Date	Group	No.	Release	Page
This Field Service Bulletin replaces bulletin "PV729-FSB395-001_M, Radio Antenna Filter, Installation" (USA77616) dated 6.2016.	9.2016	395	001	02	1(7)

Radio Antenna Filter, Installation
CHU, CXU, GU, TD

FSB 395-001, Radio Antenna Filter, Installation

(September 2016)

W3113665

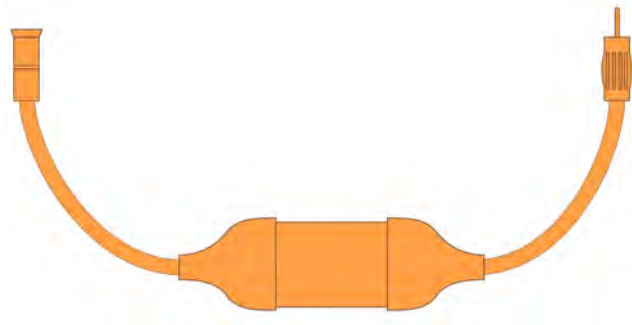
On some Mack Trucks built between August 19, 2014 and August 19, 2016 possible audible feedback may occur while using the AM/FM bands when the CB microphone is keyed. Keying the microphone could also cut the volume of the radio when using the AM/FM bands. This issue has been caused by a filtering problem inside the radio. To correct the issue a filter should be installed using the following procedure.

W3113733

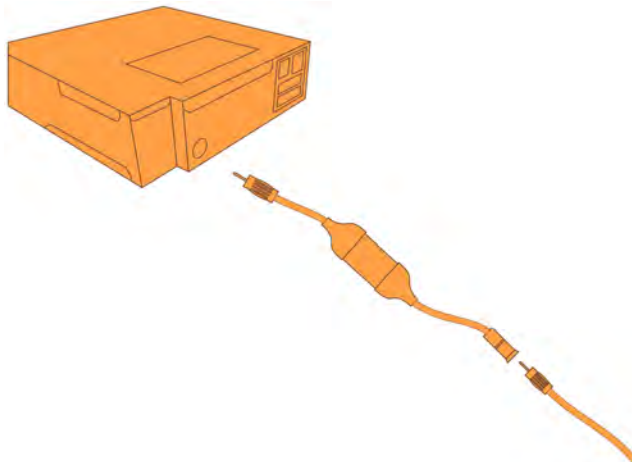
- 3 Connector the radio antenna filter to the antenna cable.

W3113792

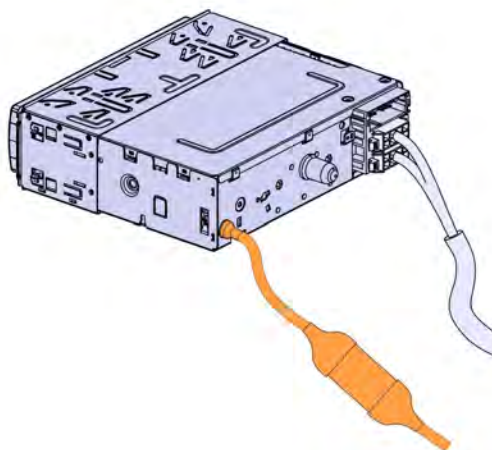
- 4 Connect the antenna filter to the radio.

W0113768

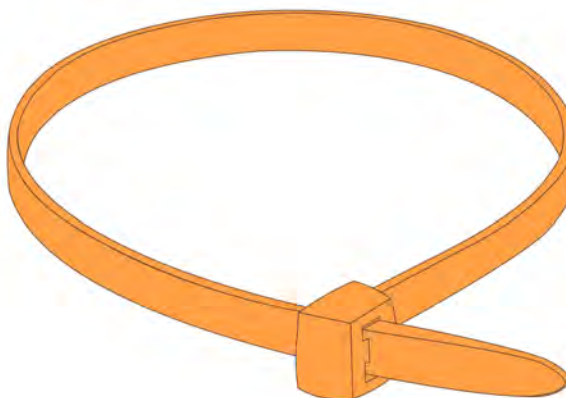
- 5 Use cable ties to secure the radio antenna filter as necessary.
